Harney Street Viaduct

ENVIRONMENTAL ASSESSMENT

Appendix C - Cultural Resources Coordination

Re: WYDOT preparation of an EA for construction of a new viaduct along Harney Street in Laramie (SHPO File # 0109KLH002)

Figure 12. Site map of Clark Street North Neighborhood (48AB2178), showing the three alternatives for connecting routes that could affect the district.

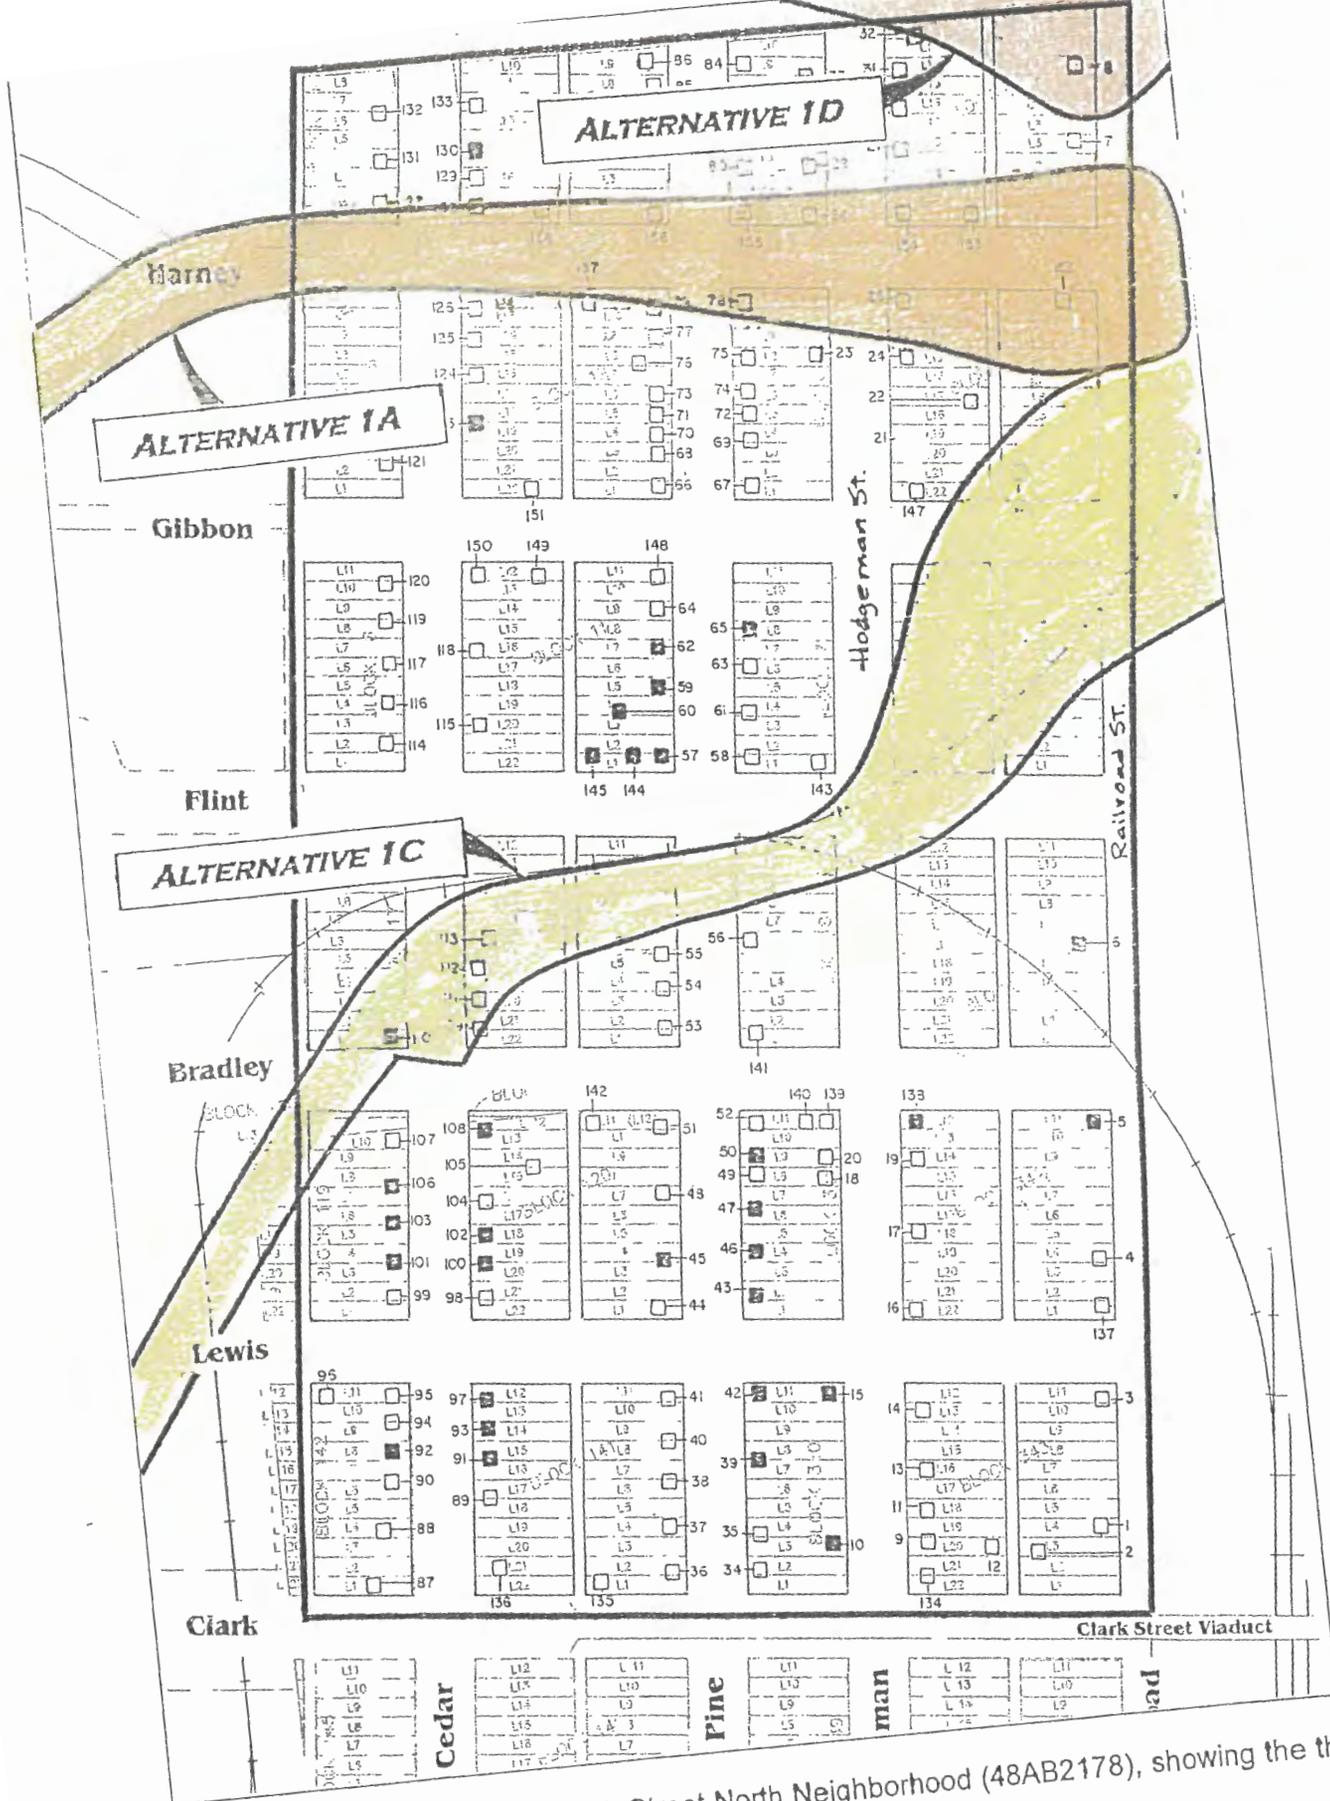
Effects to individually eligible properties are summarized on the attached spreadsheet. Please note that the individual impacts and effects on the attached spreadsheet have been assessed using large scale aerial photos with the centerline and projected toe-of-slope for each alternative plotted. These photos differ slightly from the reduced scale Figure 12 in the report, resulting in differing assessments of impacts.
